URBAN DESIGN REVIEW BOARD

STAFF REPORT

UDRB Hearing Date: July 07, 2023

Site Address: 5760 Jefferson Ave

ELEVATIONS

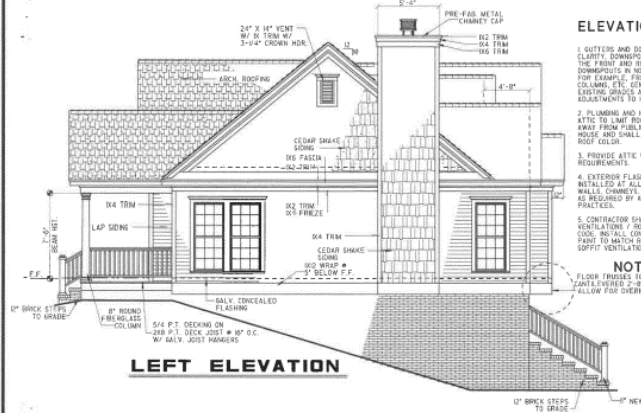
The façade that will be included in the newly built construction features a Gable & Valley Roof design with what appears to be an exterior Hardie plank finish, cedar siding and shake. The roof will include five (5) gables with added features to the front and sides of the proposed structure. The entrance of the front façade will include a ridge cap and EIFS system. The western exterior of the structure will include a fire place that will have cedar siding & shake façade. The bottom half of the home will include a red brick water table surrounding the perimeter of the home.

The proposed project meets the current district standards and would be consistent and compatible with the city's land use and development, plans, goals, and objectives. The project's design is in harmony with the general character developments in the vicinity, considering factors such as mass, building materials, placement, height, land use patterns, and consistency of exterior architectural treatment. The design components were planned in such a fashion that they are physically and aesthetically related and coordinate with other elements of the project and surrounding environment.
